Department of Energy

Subject: Supplemental Information Regarding the Tritium Producing Burnable Absorber Rod (TPBAR) Lead Test Assembly (LTA) Topical Report

RESPONSE TO NRC
REQUESTS FOR ADDITIONAL INFORMATION
Quality Assurance

7 QUALITY ASSURANCE

Figure 7-1 Quality Assurance Interfaces

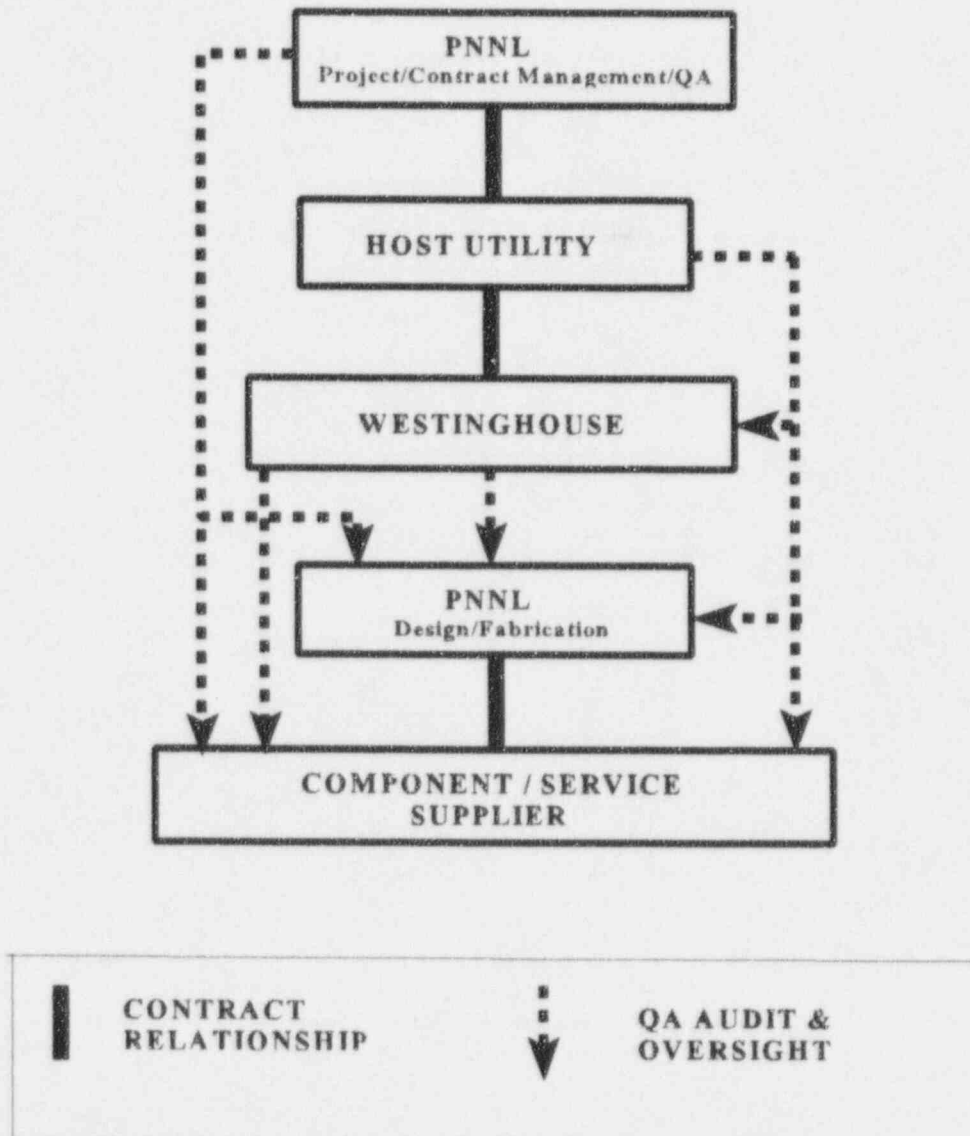
4. Define the contractual relationship among the participants identified in Figure 7-1 of PNNL-11419, including a detailed description of the programmatic controls and responsibilities related to 10 CFR Part 50, Appendix B, and 10 CFR Part 21.

Response:

Battelle, operator of Pacific Northwest National Laboratory (PNNL), is procuring irradiation and technical support services from the host utility and nuclear computer code modification services from Westinghouse Electric Corporation..

The host utility is procuring QA oversight (including qualification of PNNL as a supplier), engineering, and technical support services from Westinghouse. The host utility is contractually imposing 10 CFR 50, Appendix B and 10 CFR 21 on PNNL and Westinghouse. The host utility, as licensee of the facility, is responsible for ensuring appropriate technical and quality requirements are established and complied with prior to insertion of the LTAs into the reactor core. These activities are accomplished in accordance with their NRC accepted QA Program.

- [5] Editorial clarification; replaced NQA-1 with 10 CFR 50, Appendix B to accurately reflect the host utility quality requirements.
- [6] Editorial; Removed Regulatory Compliance and preparation of the topical report from Table 7-1 since these are not part of the QA responsibilities. Also revised Figure 7-1 to clarify that PNNL QA provides oversight of PNNL design and fabrication activities, as well as oversight of component and service suppliers (figure previously did not identify PNNL QA and implied that supplier oversight was done by design and fabrication personnel). Figure 7-1 was also revised to remove the solid line (contract relationship) between PNNL Project/Contract Management and Westinghouse since that relationship is minor.
